ALERT SERVICE BULLETIN

204B-16-71  
PSL 7000000201  
14 December 2016

**MODEL AFFECTED:** 204B

**SUBJECT:** TAIL ROTOR YOKE 204-011-722-005 CHROMATE CONVERSION COATING

**Figure 1. Conversion Coating Application Areas**

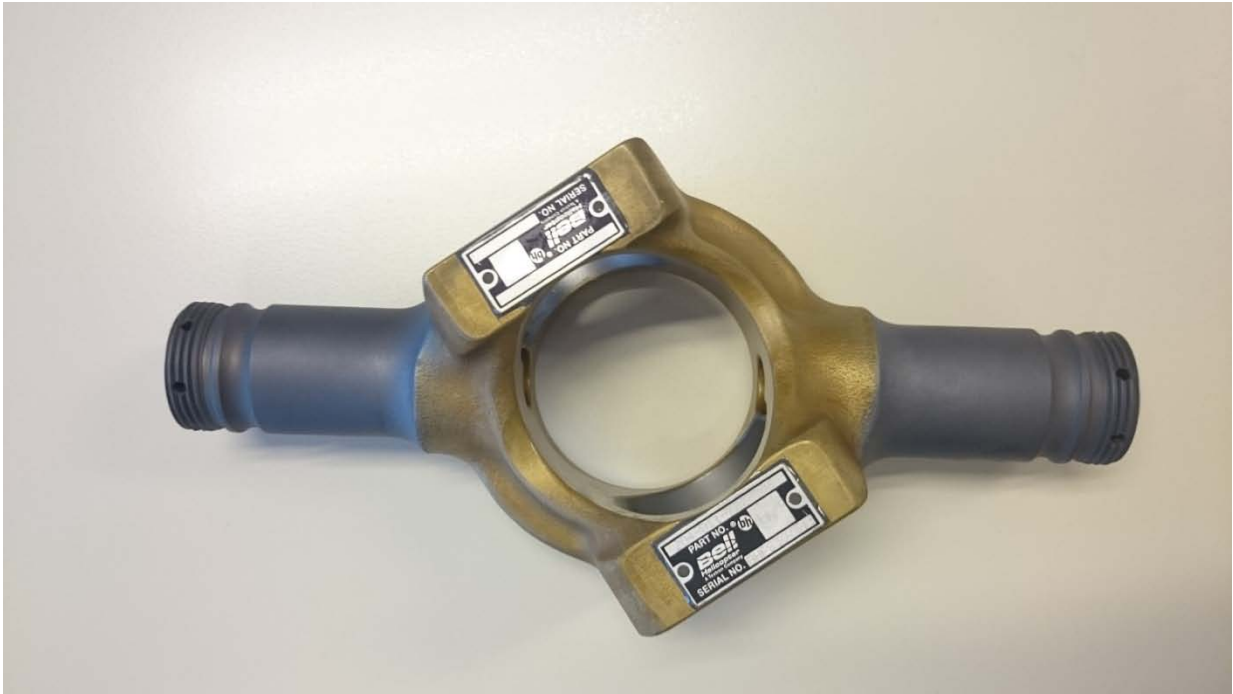
7. Apply the chromate conversion coating (BHT-ALL-SPM, Chapter 3, Paragraph 3-18). Do not apply the chromate conversion coating in the trunnion bores or on the yoke spindles. For an example of the chromate conversion-coated areas, refer to Figures 1 and 2.
8. Once the chromate conversion coating has been reapplied successfully, the tail rotor hub and blade can be reassembled (BHT-204B-M&O, Section 6).
9. Make an entry in the helicopter and component historical service records to indicate that **Part II** of this bulletin has been accomplished as a terminating action to this bulletin.
